Working of INA826 instrumentation amplifier for Pt100 RTD

The schematic below contains an INA826 used to amplify the resistance of the Pt100 RTD across J1. Gain is set to 10 through the 5.49K ohm resistor.

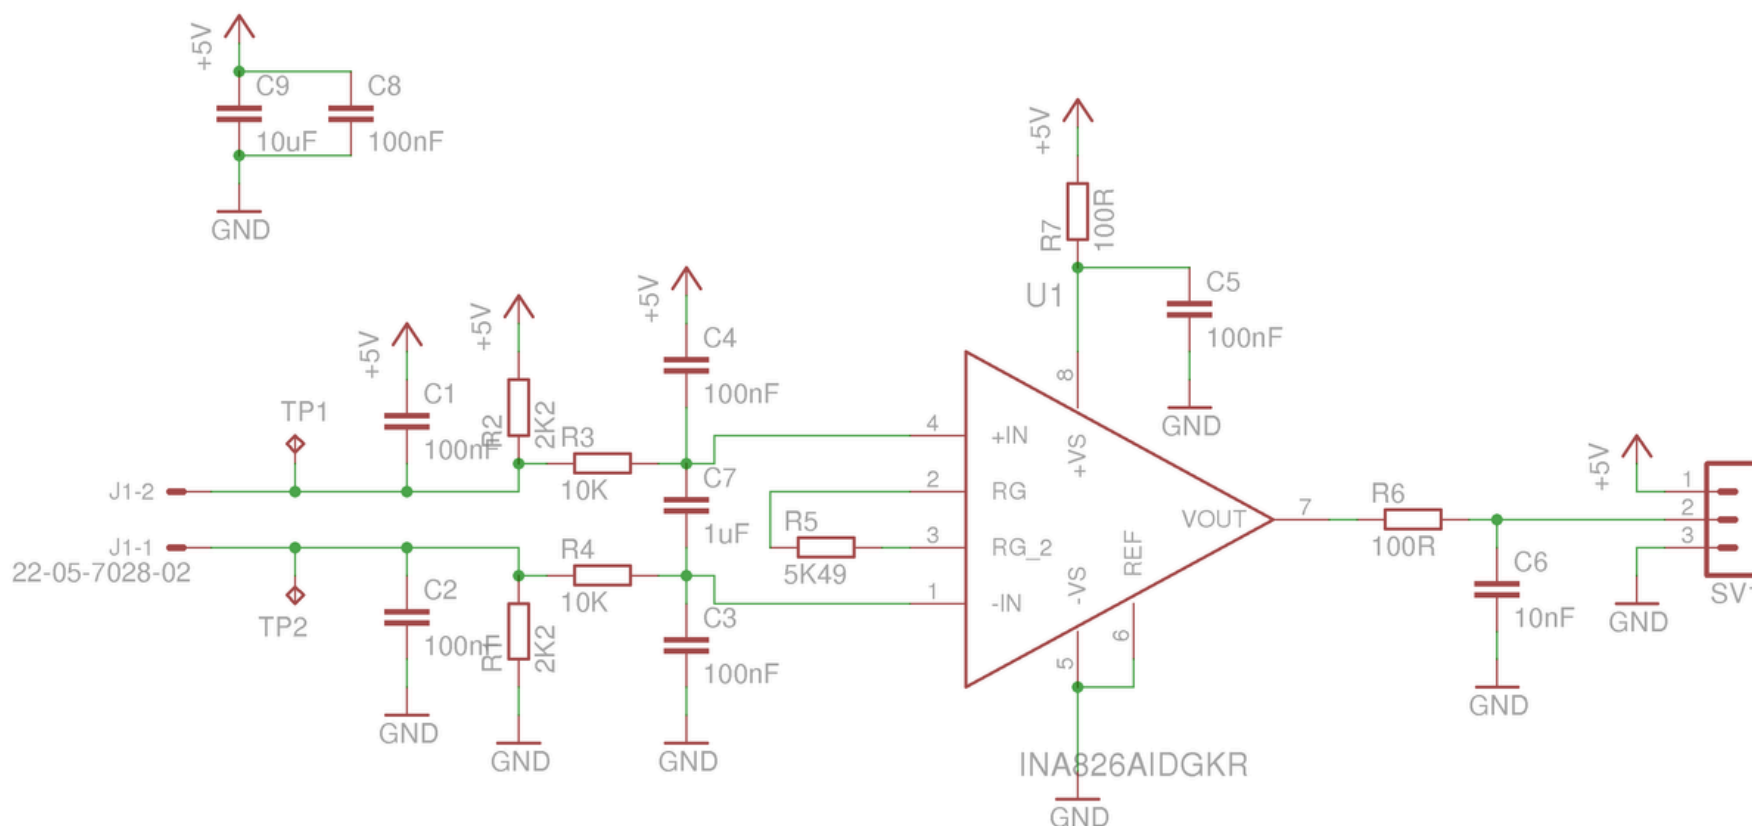
1. Is this circuit amplifying only the voltage across the RTD or are any other voltages involved?

2. Why not connect -IN to GND, and +IN to a junction of a 5V voltage divider consisting of known resistance and the RTD?
3. What is the advantage of the present schematic over the one mentioned above?

-
- 1 Please ask a question that can be answered, this is a Q&A site. You'll get better answers this way. – Voltage Spike ♦ Jul 22, 2019 at 19:46
-
- 1 You seem to have far too low a gain. [maximintegrated.com/en/design/reference-design-center/...](https://www.maximintegrated.com/en/design/reference-design-center/) – Tony Stewart EE since 1975 Jul 22, 2019 at 20:56
-
- @SunnyskyguyEE75 This circuit is being used in a 3D printer. So the Pt100 temperatures 0 C and 850 C correspond to 100 ohm and 390 ohms respectively. This circuit gives a resolution of 0.6 ohms when read by the 12 bit ADC on LPC1768. – quuwuza Jul 22, 2019 at 21:06 ✎
-
- OK I wasn't expecting you need 0°C and so much dynamic temp range. I think you want 0.1°C resolution not 2 deg. – Tony Stewart EE since 1975 Jul 22, 2019 at 21:23 ✎
-

So is the equivalent RTD configuration 2 wire or 4 wire in the present schematic? – [quwuwuza](#) Jul 22, 2019 at 20:38

Is there a purpose behind R2 and R11? Why not just pass +5V through the RTD without the resistors? – [quwuwuza](#) Jul 22, 2019 at 20:34

It's amplifying the voltage across the RTD. The 10k resistors in conjunction with the 100nF caps have a filter time constant of 1ms.

The common mode of the instrumentation amplifier would not support low voltages when at 5V as shown in the graphs below (at a gain of 10 the common mode would be between the blue squares as only gains of 1 and 100 are shown). If the output of the amplifier

were at 5V then the input needs to be centered around 2.5V or the instrumentation amplifier would not gain up the signal correctly.

The ability to amplify all of the RTD's resistance range.

R2, R11, and the RTD are connected in series to the +5v. This makes current flow through the thermometer, and the diff amp senses the voltage drop across it. R3 and R4 along with c4, c7, and c3 filter out any high frequency noise. C1 and C2 also filter high

1 frequencies out, but are not really needed or a good idea. R6 and c6 are another filter. R7 is to prevent any resonances on the power lines for the diff amp. C5 is a power bypass capacitor.

1 R2 and R11 set the nominal current through the RTD to 5/4.1 ma. Perhaps this is the desired current.? – [user69795](#) Jul 24, 2019 at 2:51
